***Mingara Recreation Club Seniors Housing, Tumbi Umbi (SSD-63475709) – Council Submission***

Council raises the following outstanding concerns in relation to the amendments undertaken by the applicant regarding the proposed development:

**Figure 1:** Cars parked on the grass near the athletics track on Thursday, 18 August 2022 and proposed car parking relocation

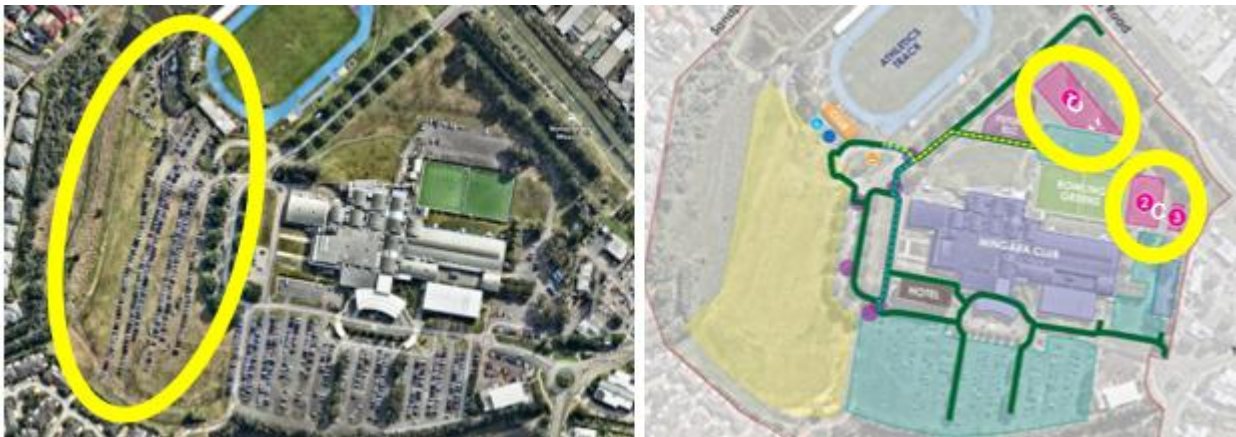
The proposal to utilise existing grassed areas on the site for car parking which is impacted by flooding is not supported by Council. Council considers the proposed car parking will not be an adequate solution to the displacement of the existing parking currently adjoining the south western boundary of the athletics track and on the north west of the site (refer to Figure 1).

The proposed car parking should be re-located within the site which will not be impacted by flooding. This will require amended plans and potentially a revised Traffic and Parking Impact Assessment Report in order to demonstrate that the revised car parking area will not be impacted by flooding and the layout will be satisfactory in terms of manoeuvrability and traffic movements.
